## Leeds' plans for flood easing from Apperley Bridge to Calverley

### *Regarding Leeds' flood-mitigation plans for Apperley Bridge, Bradford*

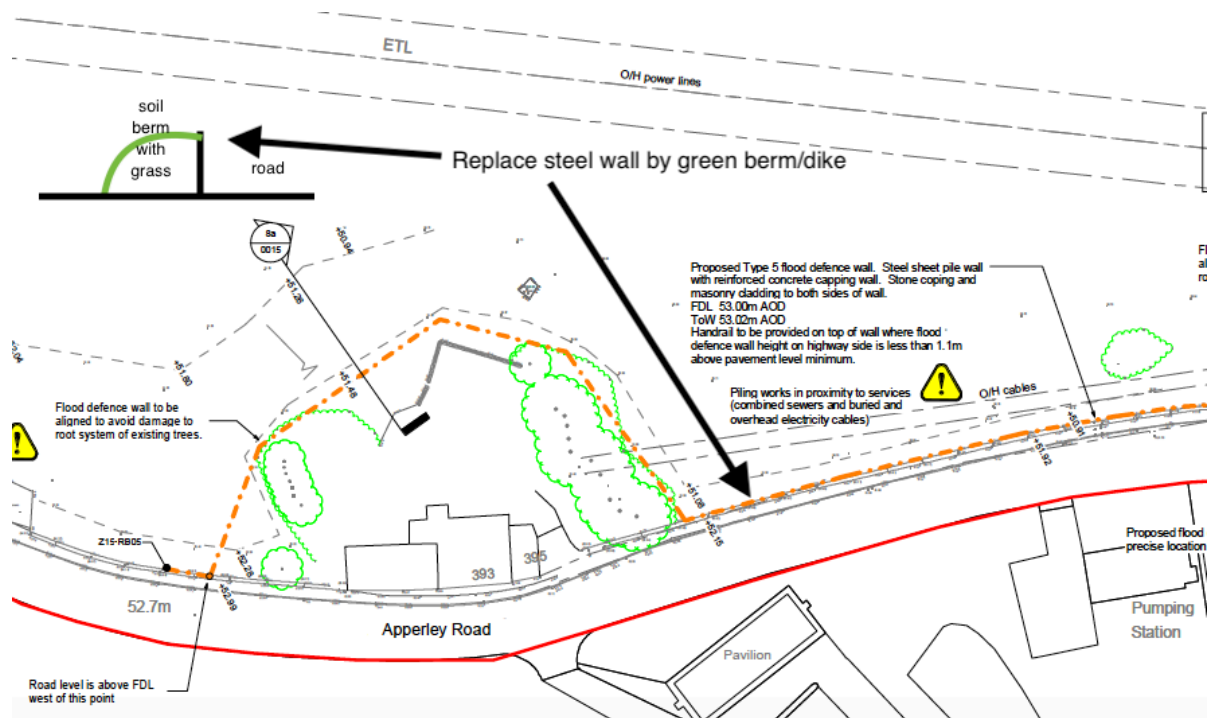
- a) ***An alternative, possibly cheaper and certainly greener, solution to the steel-sheet pile wall*** on the South side of the river along the minor road to Apperley Bridge (see drawings in [1] and Fig. 1) is *a berm formed by clay/soil with grass on top*, e.g., clay/soil from the in-situ flood plain, which would result in a zero-or-negative volume change, concomitantly creating more-or-zero change in floodplain-storage capacity. This would be an example of a green *Nature Based Solution* (NBS), a berm or dike, which can fit seamlessly and naturally to the existing stone wall (with repairs of that wall where necessary) along Apperley Road. See also Fig.1.

***Question 1:*** *How does the steel-sheet pile wall look (there is no image); what are its costs relative to green dikes/berms?*
- b) There is a steel-sheet pile wall planned along the North side of and directly along the river to protect the garage (see drawings on [1] and Fig. 2). ***The garage, however, has recently moved and only a car wash remains.*** The car wash can also be moved (both garage and car wash are/were polluting the river), with the soil cleaned, lowered and made into green

Figure 2: Graphs relating to points b) and c) above. Subsection of drawing in [1] along River Aire in Apperley Bridge. Fat arrows and green/red text added by OB.  
(Grid reference: SE 19475 37978)

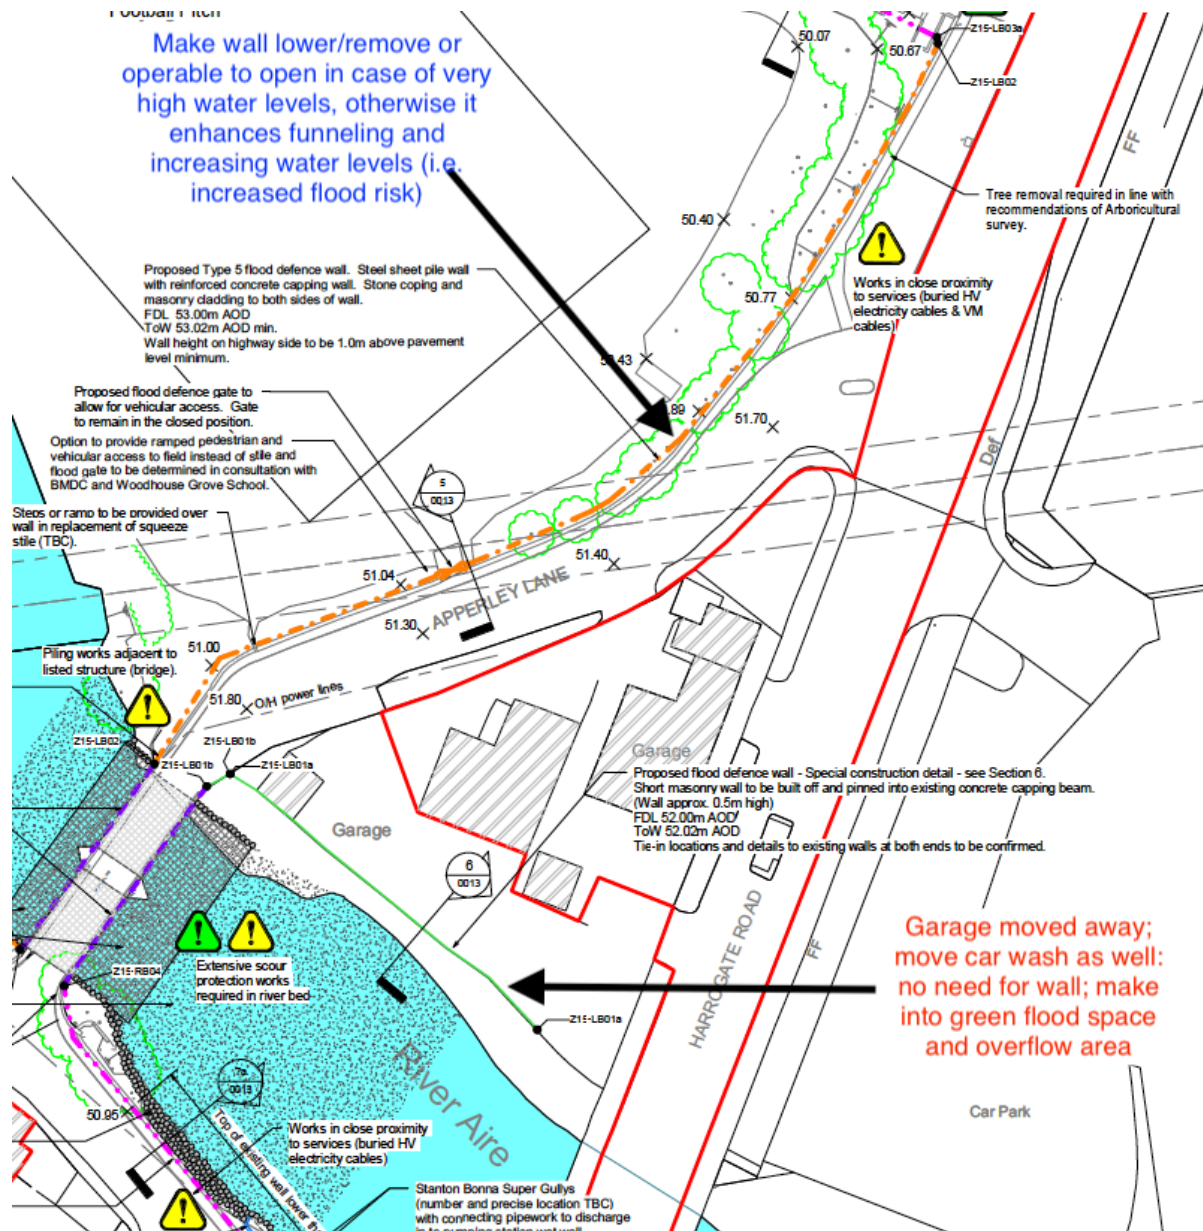
space; the river bank there can also be widened and lowered in places, thus giving more room to the river and better preventing floods on the built-up South side because the water can go somewhere (i.e. it can flow onto the floodplain as intended by nature). ***Hence there seems to be no need for this steel-sheet pile wall on the North side along the river between the two bridges. See also Fig. 2.***

- c) A closed steel-sheet pile wall on the North side of the river along the minor road coming off the old Apperley Bridge will lead to enhanced funneling of the river and, hence, increased river-levels, especially under climate change, which, recalling point (i) above, puts the houses on the South side at increased risk of flooding. Instead, these walls should be lowered, not strengthened/raised, or possibly several operable gates should be included that can be opened at very high river levels to lessen the pressure on the South bank flood-defense wall. In conjunction with b) above, flood waters can then flow over this road (in a case without wall or with a lowered wall) and the flood waters can be led away via the new lowered space between the two bridges. See also Fig. 2.
